January 10, 2020 UPDATE (6<sup>th</sup> Supplemental Submittal)

**RE: KMART REDEVELOPMENT – DRB SUBMITTAL FOR SITE PLAN**

**DRB PROJECT NUMBER: PR –2019–002677**  
**APPLICATION NUMBER: SI-2019-00252**

DESIGNED JS DRAWN JS CHECKED SG DATE 12.03.2019	<b>REVISION</b> 1 2	<p>PROJECT NAME: CARLISLE MARKETPLACE</p> <p>SHEET TITLE: CONCEPTUAL GRADING</p> <p>SUBMITTED FOR: DRB SITE PLAN</p> <p>SHEET NUMBER: C-200</p>
--	---------------------------	---

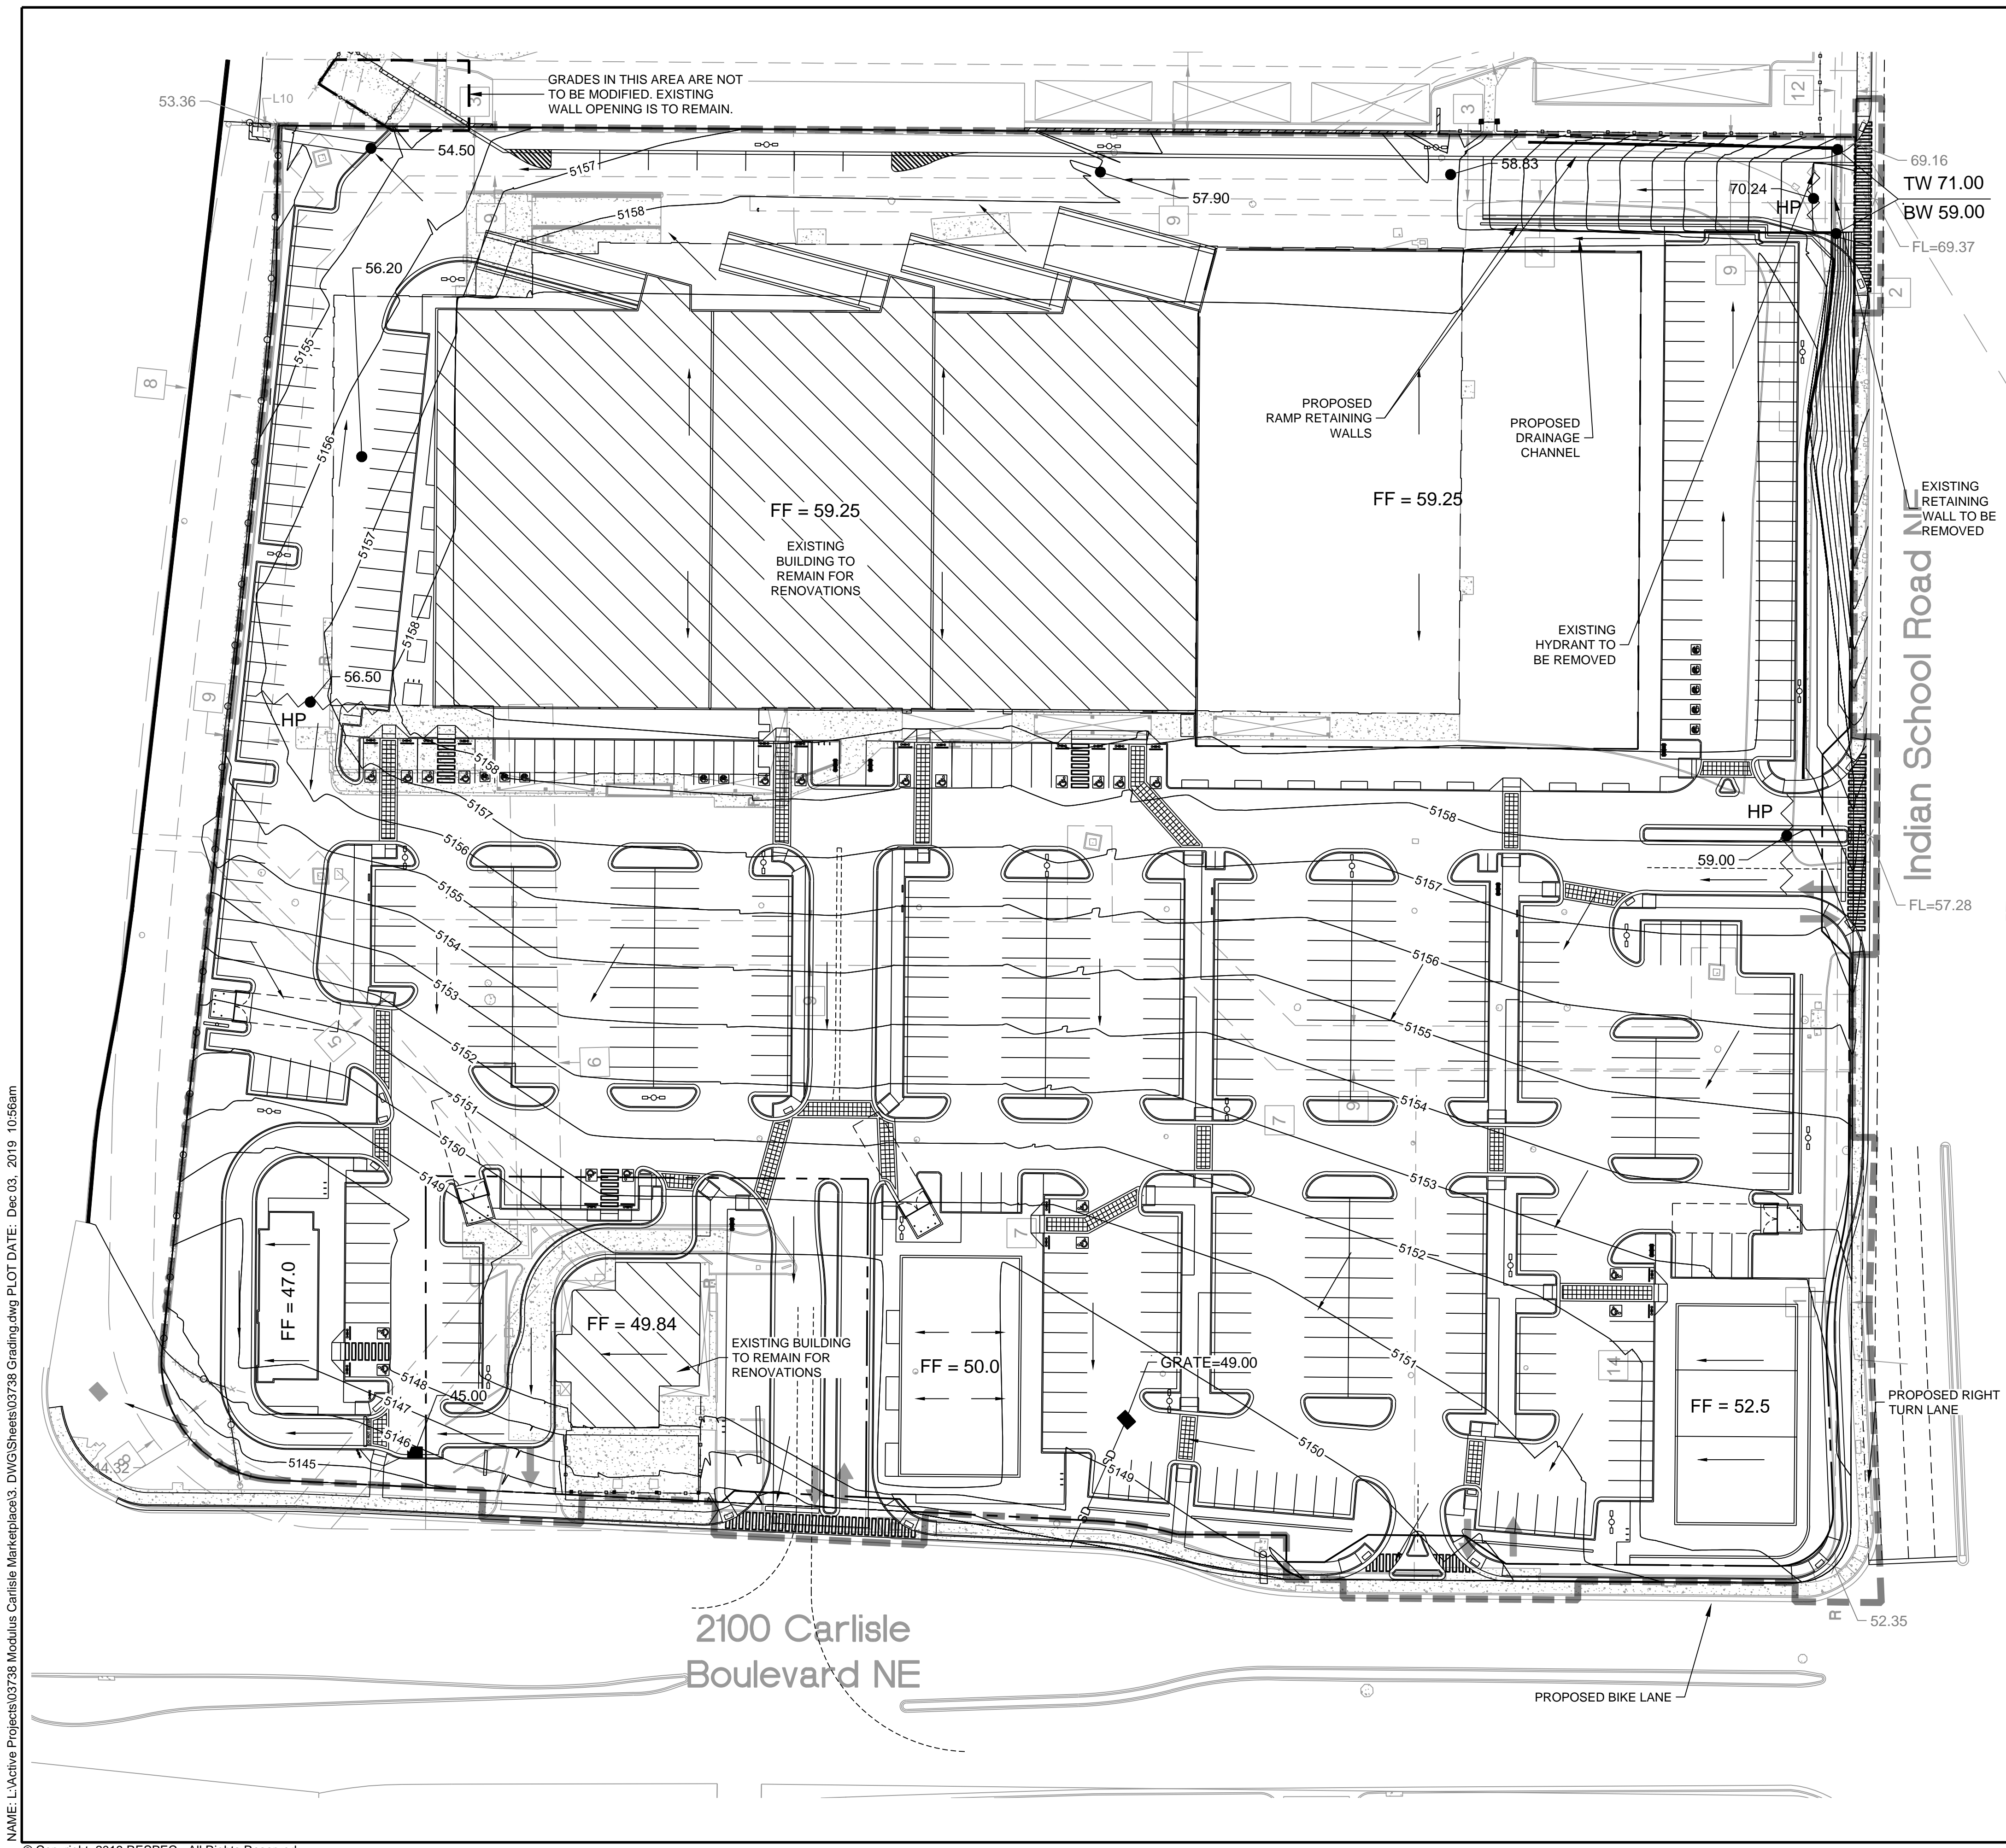
1. Hydrology has an approved grading plan with Engineers stamp date: 12-3-19 and it needs to be included in the Site Plan.
  - a. **See Engineers stamp dated 12-3-19 on sheet C-200: Conceptual Grading**
2. No objection to the Infrastructure List.

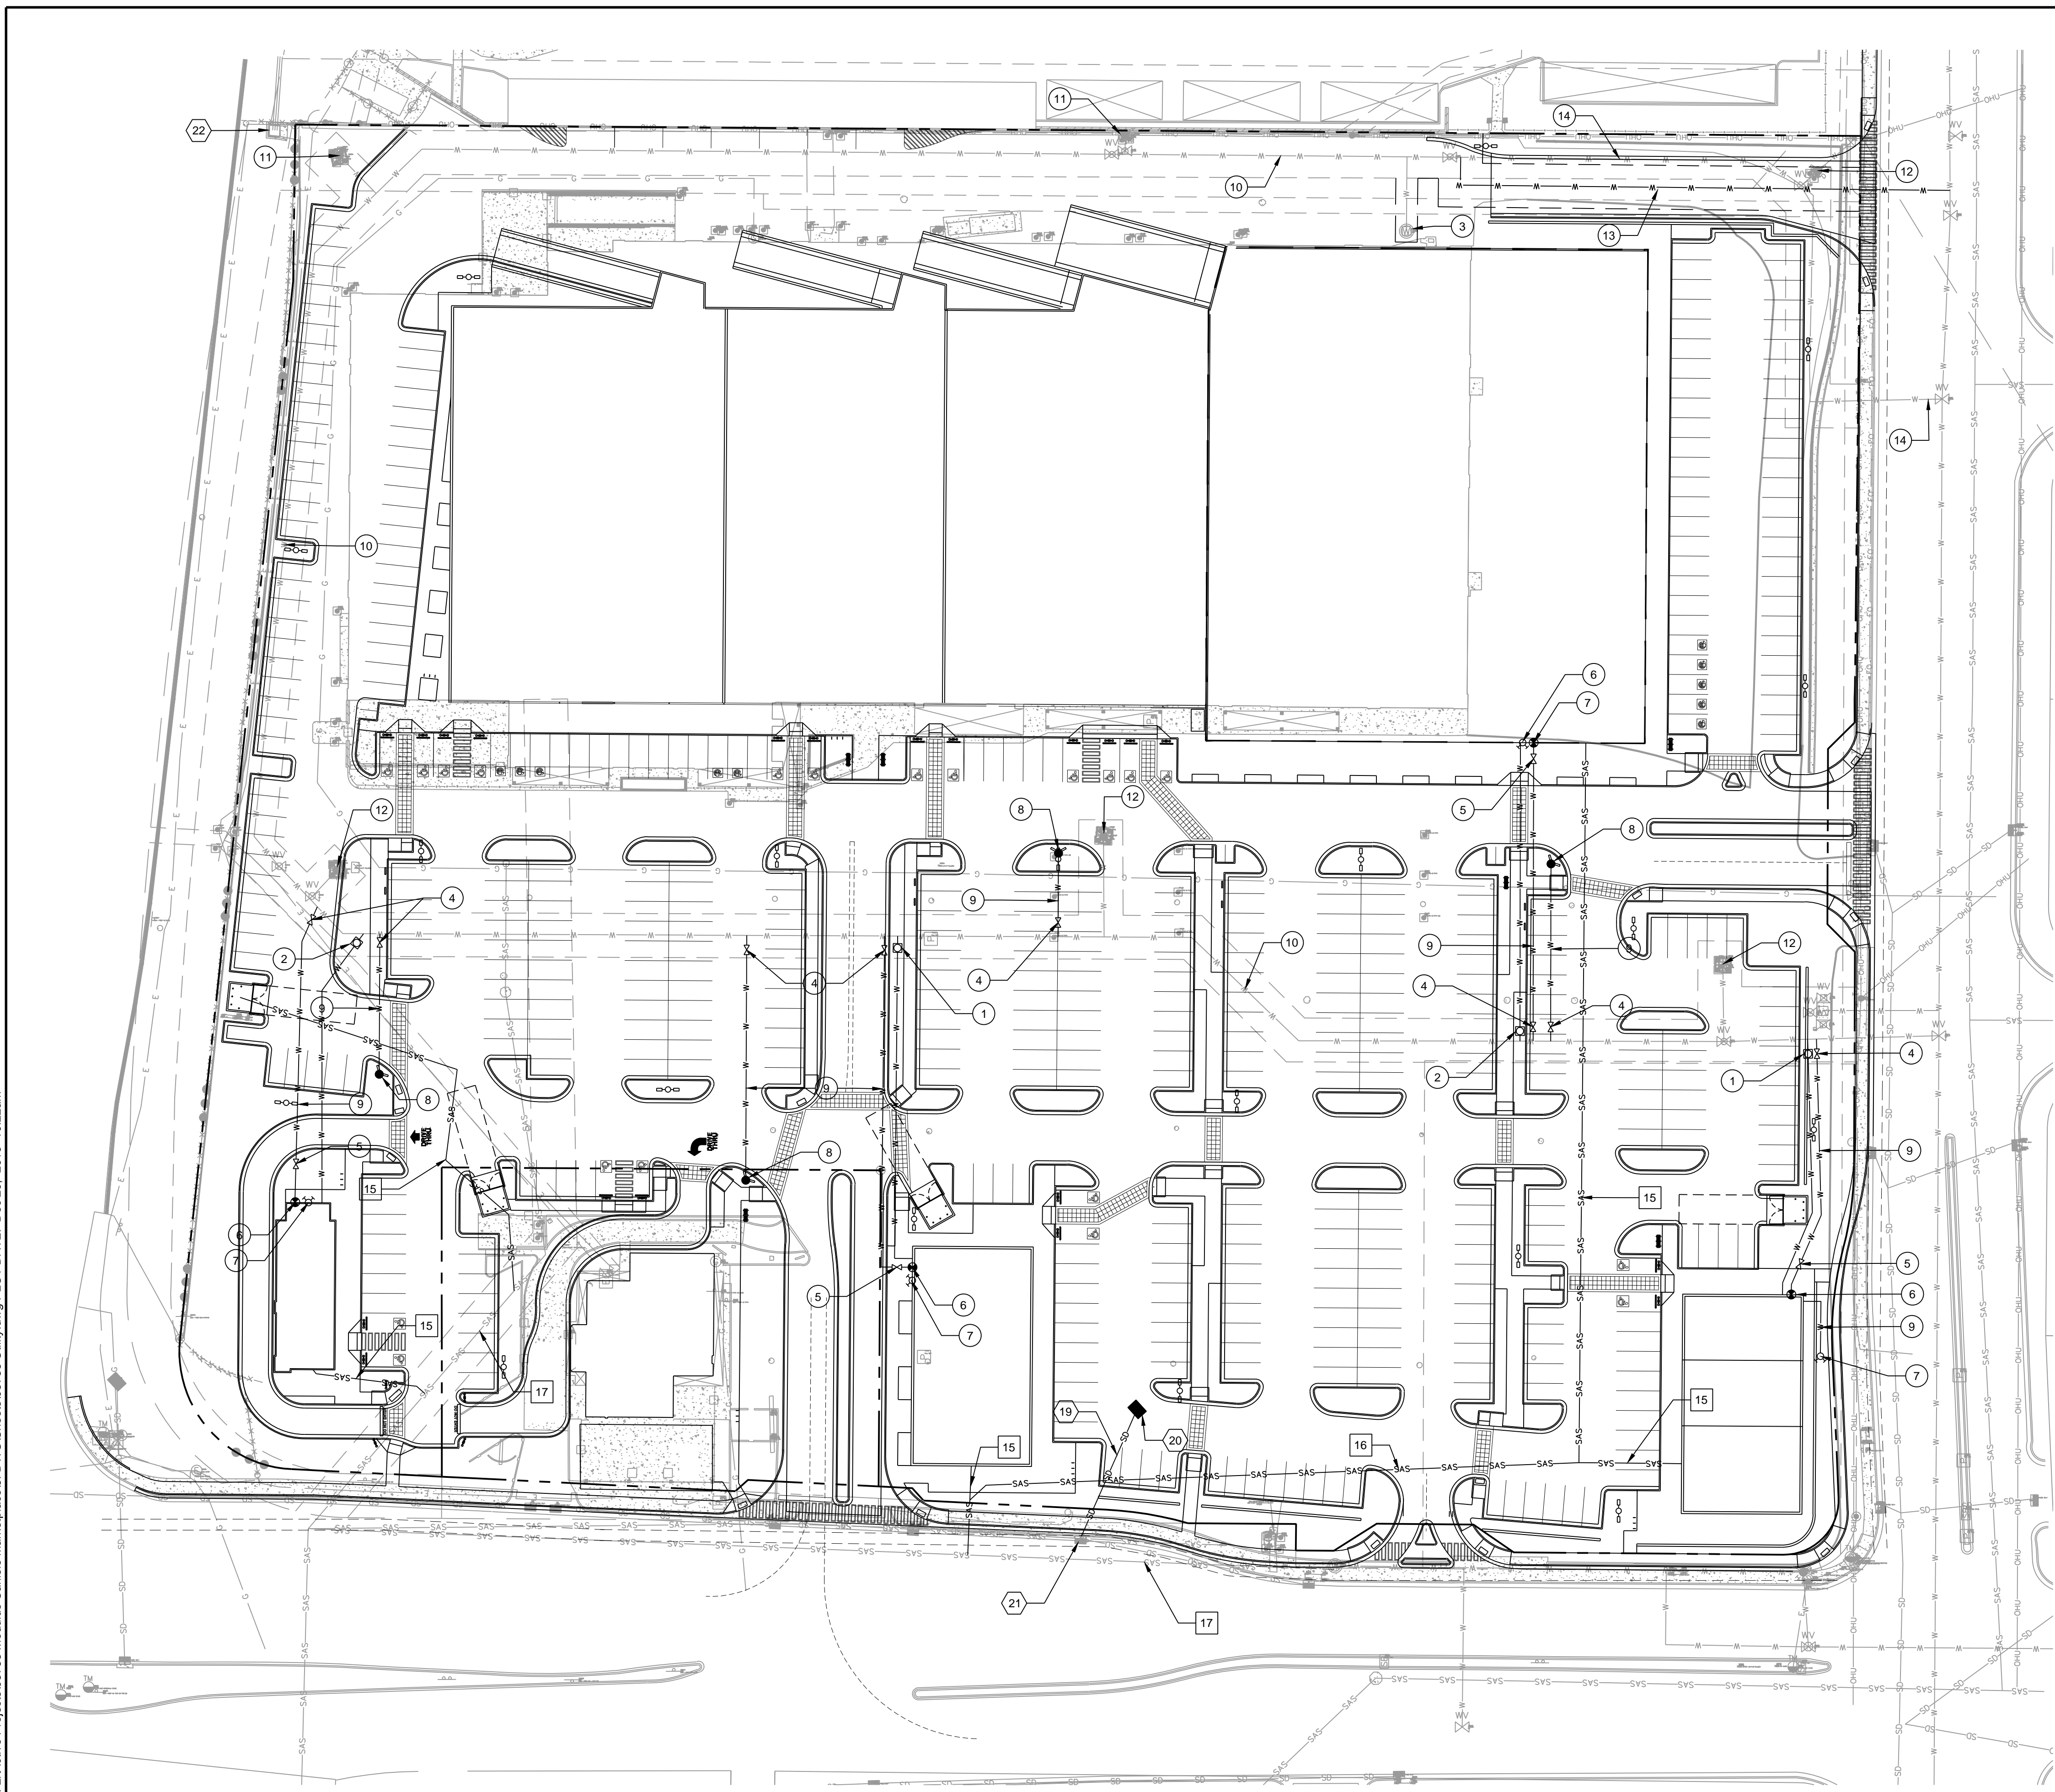
- c. Proposed onsite fire hydrants shall be deemed private. It is understood that there are several onsite public fire hydrants but the proposed fire hydrants legs are quite long and resemble a private fire line.

- i. Response was all existing and proposed hydrants are now shown as private. Simply renaming the existing public hydrants to private does not convert them as such. Please coordinate with Maps & Records and label accordingly. Some onsite existing fire hydrants may be in easements, making them public. Please confirm.

1. How will the existing public fire hydrant(s) be converted to private as per Note 11? If there is an existing easement, then this will need to be vacated. Otherwise, it will remain as public.

- d. **All existing hydrants onsite are public. All new hydrants, as noted on the plan, will be private. Most of the existing hydrants onsite will be removed with the exception being two hydrants along the eastern property boundary. These two hydrants will remain public hydrants within the existing easement as indicated on the revised plan.**

Carlisle Market place  
Waterline Exhibit  
November 15, 2019

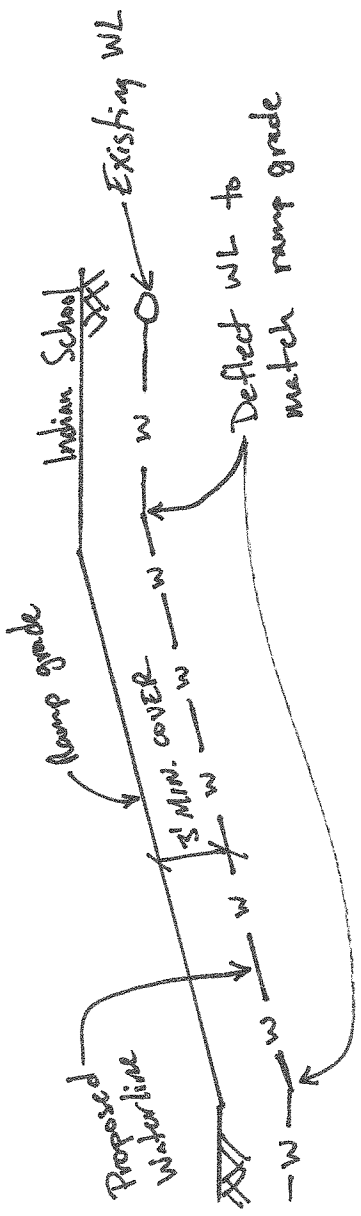
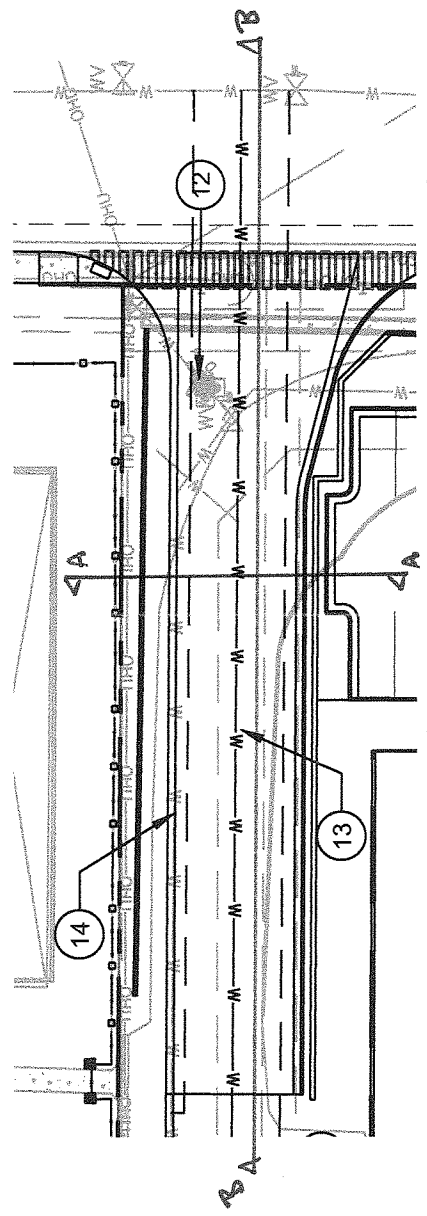
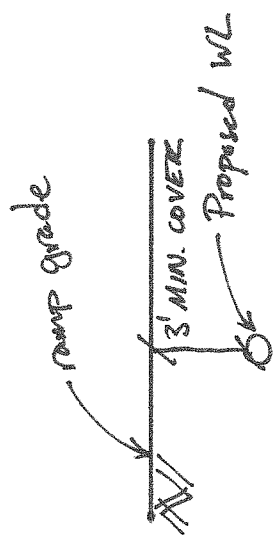
- a. Previously requested cross section and profile of this waterline, however these were not provided in the utility plan.

- i. **See attached Waterline Exhibit dated November 15, 2019**
